REVIEW OF THE KINGSTON FOSSIL PLANT ASH SPILL ROOT CAUSE STUDY AND OBSERVATIONS ABOUT ASH MANAGEMENT

2008-12283-02
July 23, 2009

Peer Review of the AECOM Root Cause Analysis of TVA Kingston Dredge Pond Failure
Kingston Dredge Pond Failure Investigation Report, D-2009-01
Tennessee Valley Authority, Office of the Inspector General
July 2009, prepared by Stantec, Miller & Associates, Inc.

Figure 2 Osterberger/Split Spoon Samples and CPT Sensitive Soil (Slimes) Thickness, Ft.

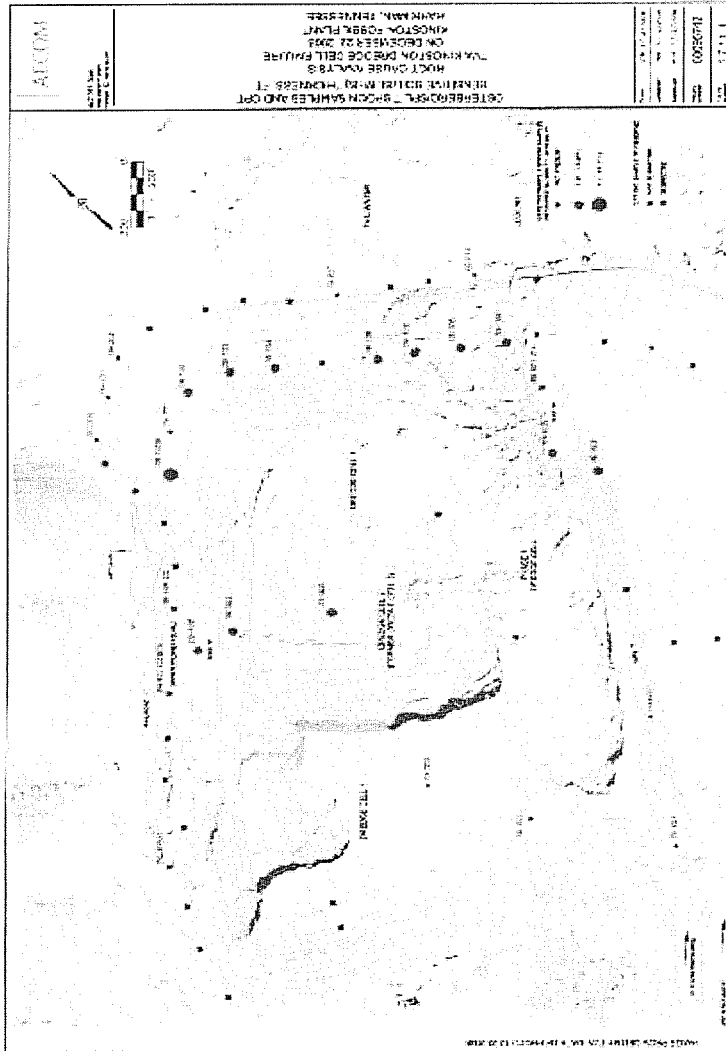
AECOM discussed the thin layer of slimes beneath the dikes of Dredge Cell 2, per item 3 above, which was discovered during its subsurface investigation (see **Figure 2**). Slimes do not exist beneath Dike C. Although the properties of this slime layer suggest it as a potential slippage surface based upon mathematical modeling, it is MM&A's opinion that it is not the only possible slippage surface. AECOM documented that slimes were not found in some locations, were not of consistent thickness, and had properties very close to those of the ash material itself.

TYPICAL SECTION NEAR WET AREA

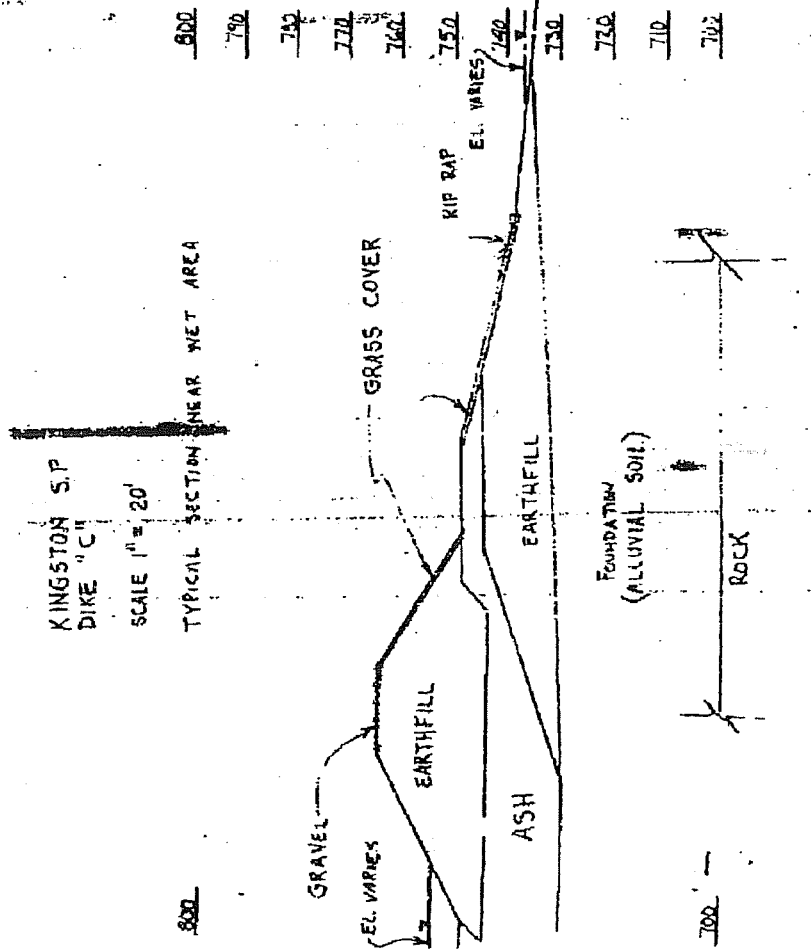
In April 1985, an internal memorandum written by a TVA engineer raised serious concerns about the stability of Dike C of the Kingston ash storage facility.¹⁴ This memorandum states that Dike C had not been built according to design drawings. It further states that the dike's "as built" factor of safety was less than desirable and therefore recommended that plant personnel inspect Dike C daily. When asked by the OIG to review this memorandum, Marshall Miller stated that the memorandum:
